STAFF REPORT SAN CLEMENTE PLANNING COMMISSION

SUBJECT: **Public Hearing Project (PHP) 23-196, Amendment to the Master Plan for Development of Cornerstone Community Church,** to demolish an existing garage, remodel an existing office, and construct a new 3,278 square feet multipurpose building with a 3,040 square feet unfinished basement to replace modular structures located at 702-710 Avenida De La Estrella within the Residential Medium (RM) Density Zoning District and find the project categorically exempt from the California Environmental Quality Act. The project requires an Amended Conditional Use Permit (CUP 23-197) and an Amended Development Permit (DP 24-208) related to these changes to the previously approved master plan for the church campus.

DMT PRELIMINARY LANDSCAPE SUBMITTAL REVIEW AND APPROVAL

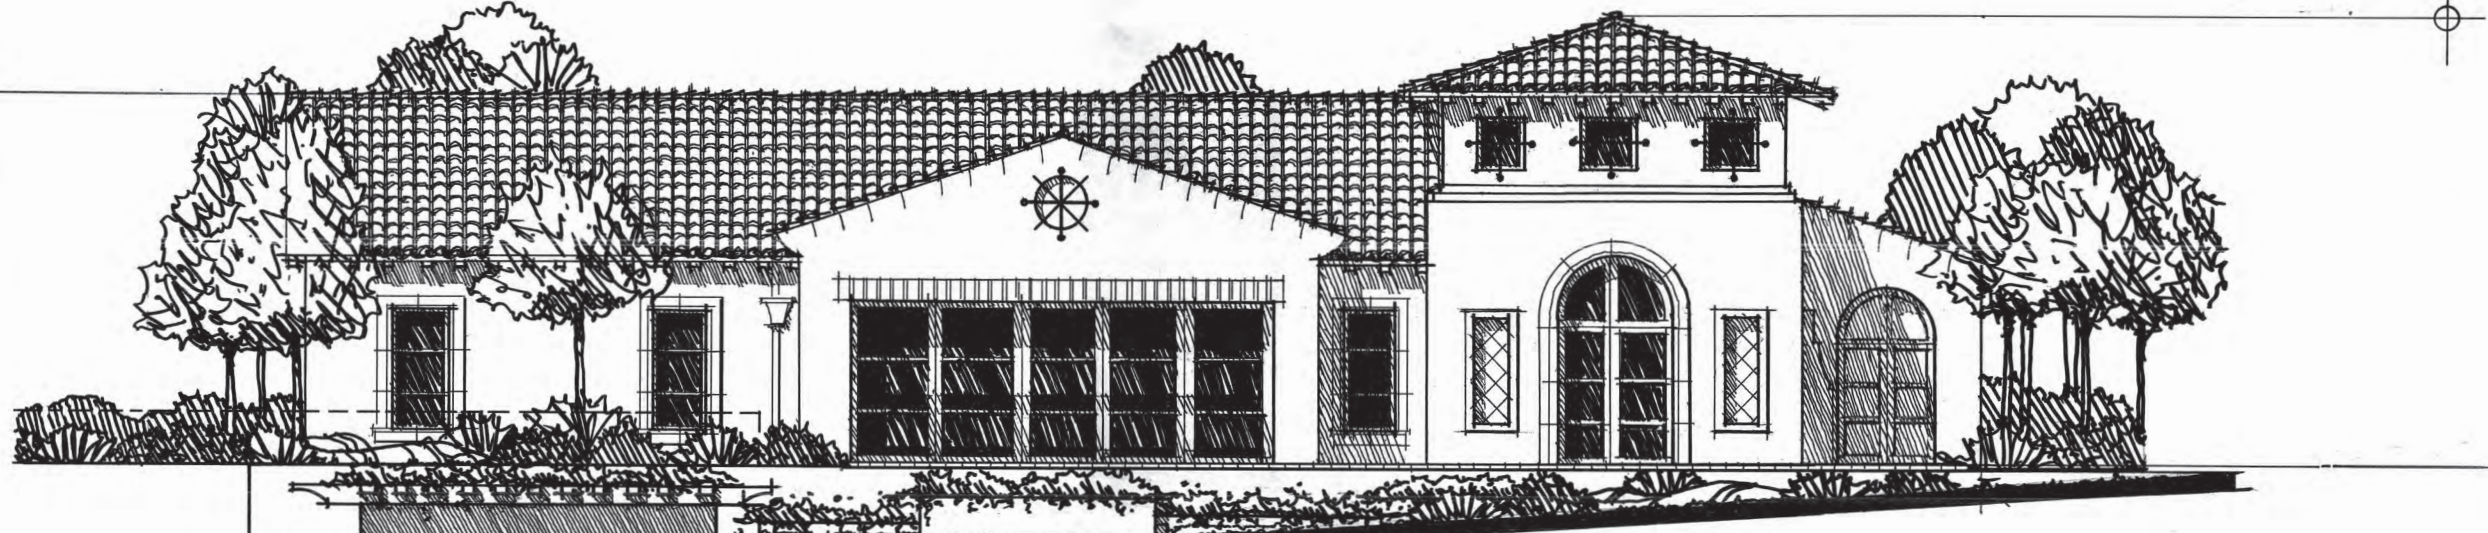
1. Typically *Ceanothus* have poor results in San Clemente soils, unless in slope conditions. Provide an alternative substitute.
2. Confirm at least 60% native plantings are provided.
3. Provide drip irrigation along with MAWA calculations.
4. Provide a site specific agronomic soils report with recommendations and confirm compatibility with proposed plants.
5. Provide 15-gallon size shrubs around any utility enclosure, trash enclosure and backflow preventer for screening.
6. Follow City of San Clemente landscape and irrigation submittal requirements.
7. Show all above and below ground utilities on final planting plans.
8. Note minimum field observation visits required by Landscape Architect on plan.
9. Provide a California licensed Landscape Architect stamp on the final Construction Documents.
